CO-OP MINING COMPANY

RE: Co-Op Bear Canyon Mine Ammendment
Mining Sequence and Ventilation
Plan.

BLIND CANYON INTAKE PORTAL

PROPOSED PORTAL

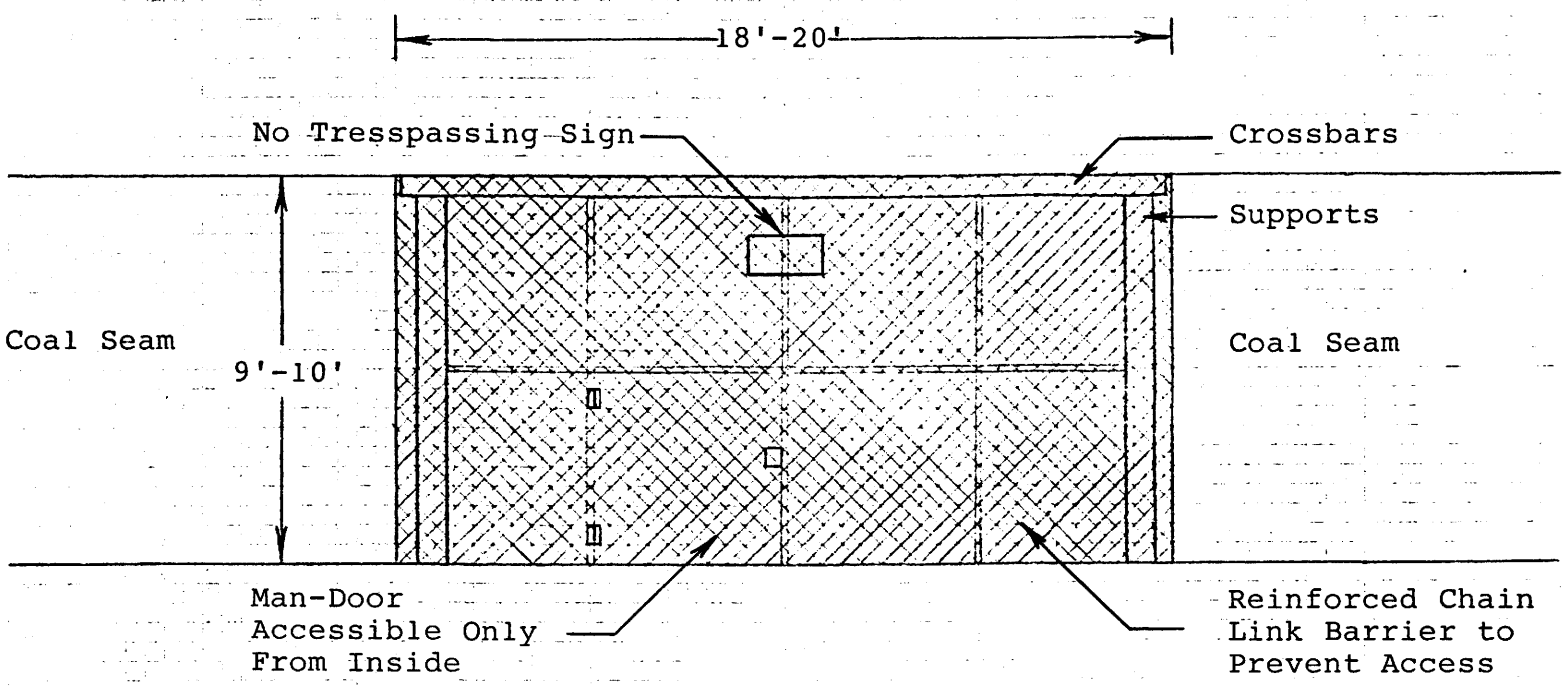
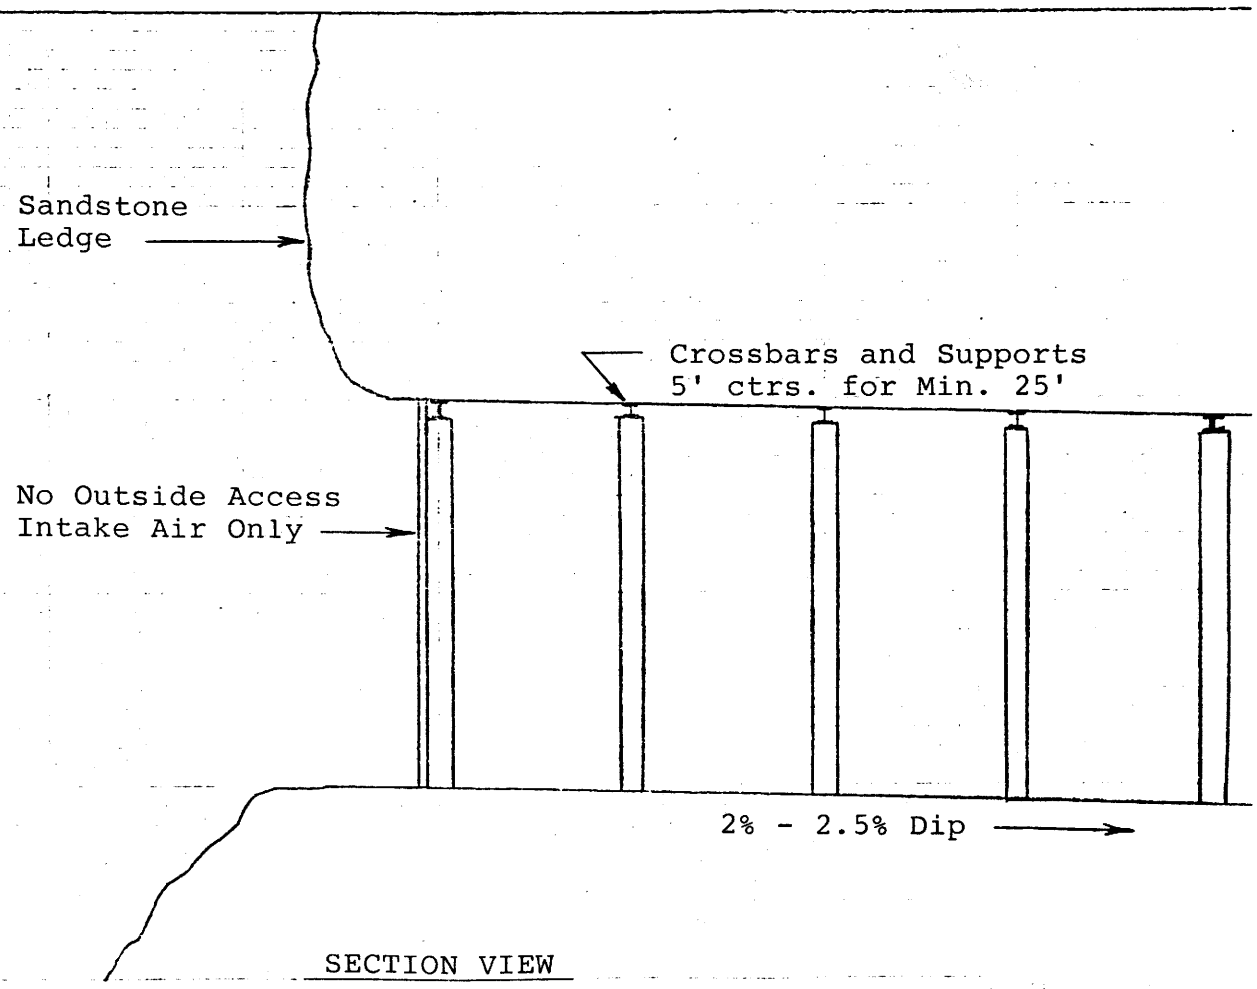
In order to facilitate adequate ventilation across the working face as mining advances from the existing intake portal and to provide an alternative escape way, Co-Op Mining requests approvals of the Blind Canyon Portal as shown on Plate 3-4.

The portal will be supported by 4" steel "I" beams placed on 5' centers for a distance of 25' into the sope. The roof will be bolted and shielded as needed with a combination of $\frac{1}{4}$" plate and chain link to minimize sluffing of rock. The entry will be reinforced and covered with chain link and posted with a "No Trespassing" sign. There will be an escapeway door installed which will only allow

access from within the mine. The chain link will prevent access of people as well as large animals which could theoretically utilize the portal for denning. (See attached illustration).
